CITY OF ALBUQUERQUE

RE: **Jomar/Martinez Residence**
2123 Candelaria NW – Lot 1
Request for Pad Certification – Accepted
Grading Plan Stamp Date: 8/23/18
Certification Dated: 1/28/19
Drainage File: G13D035

ENGINEER'S SEAL 8/23/18 8/1/18 DAVID SOULE P.E. #14522	2123 CANDELARIA RD JOMAR CANDELARIA RESIDENCE	DRAWN BY DEM
	GRADING AND DRAINAGE PLAN	DATE 7-31-18
 1608 CENTRAL AVENUE SE SUITE 201 ALBUQUERQUE, NM 87106 (505) 972-0899		JAMAR CANDELARIA G&D
		SHEET # C1
		JOB #

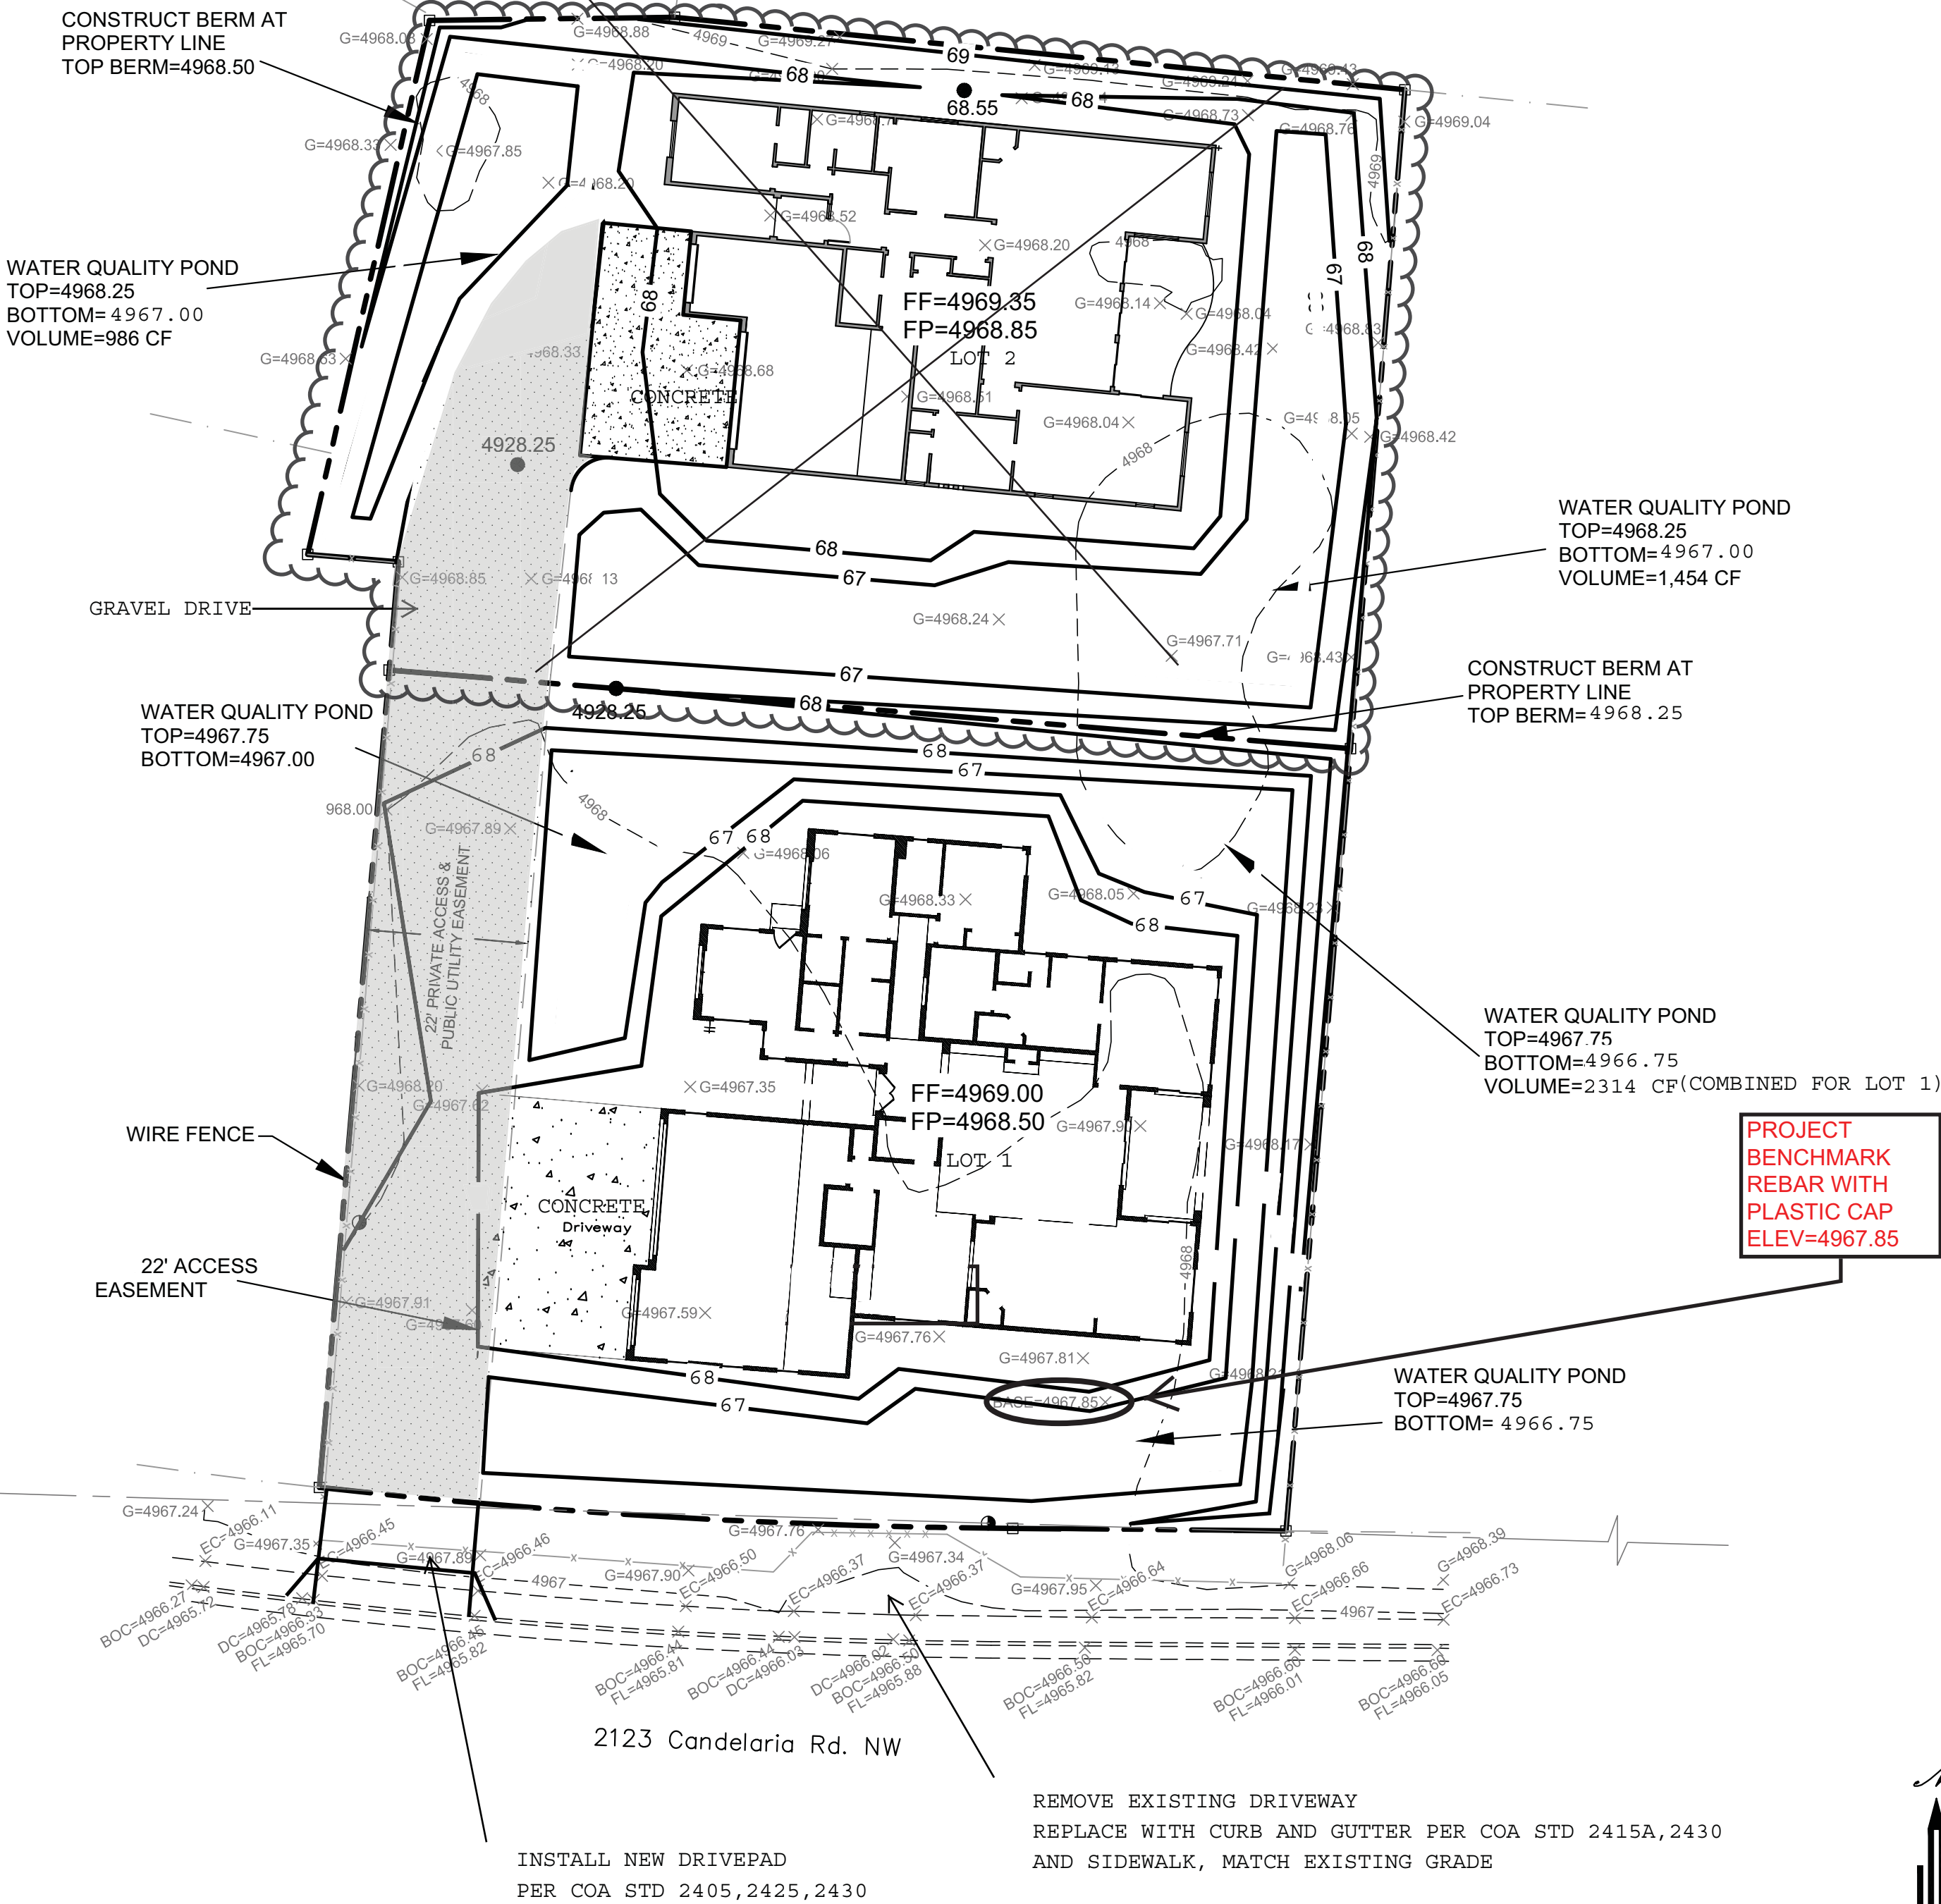
Based on the submittal received on 1/28/18, the Engineer's Certification is approved for Building Permit for Lot 1.

Prior to Certificate of Occupancy (For Information):

1. Engineer's Certification, per the DPM Chapter 22.7: *Engineer's Certification Checklist For Non-Subdivision* is required to ensure the site, ponds, and the grades along the property lines were not disturbed during home construction.
2. The site must be surveyed and pond volumes certified.
